SITE
41 HIGH STREET
SPALDING LINCOLNSHIRE

PROPOSAL
CHANGE OF USE FROM COMMERCIAL USE TO SINGLE FAMILY HOUSE WITH EXTERNAL ALTERATIONS AND NEW BALCONY AT REAR

AMENDED PLAN
Ref.

DRAWING NO: 94-HR/3

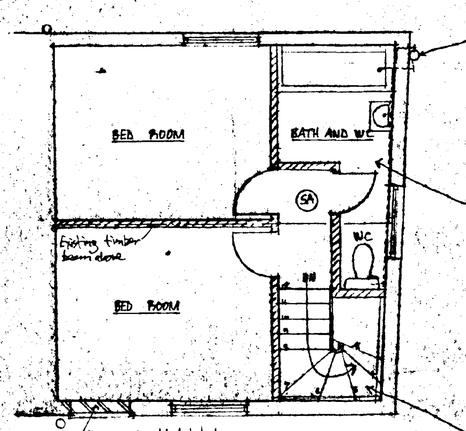
Revision 3
Sound insulation detail between No. 41 & adjoining Blacksmiths shop amended.

REAR ELEVATION 1:100
FROM RIVER

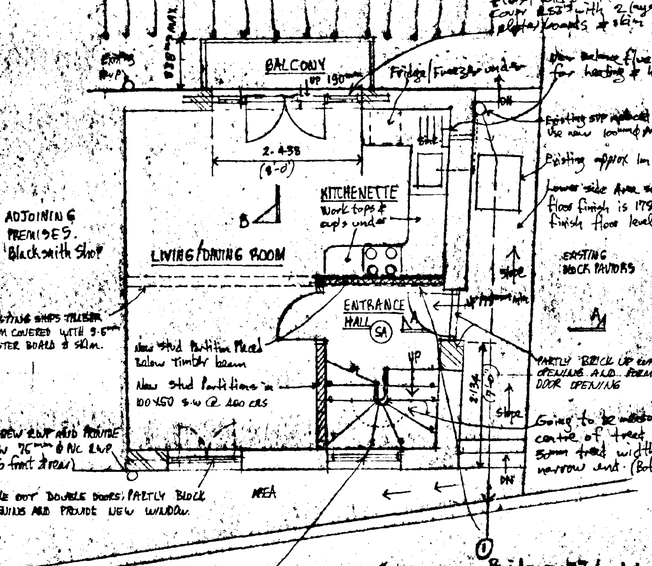
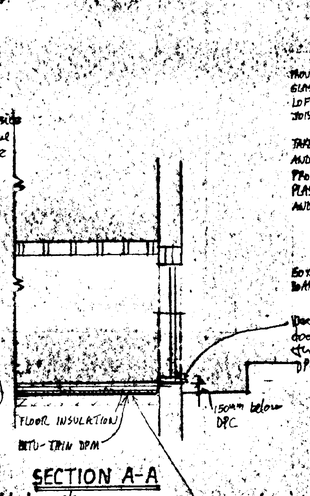
NOTE 'x'
Requirements of National Rivers Authority.
THE RAILINGS etc AROUND THE PROPOSED BALCONY TO BE REMOVABLE TYPE & TO BE REMOVED as & WHEN REQUIRED BY THE NRA MAY GAIN ACCESS AT REAR TO CARRY OUT REPAIRS. RAILS WILL BE RE-FIX AFTER ACCESS etc.
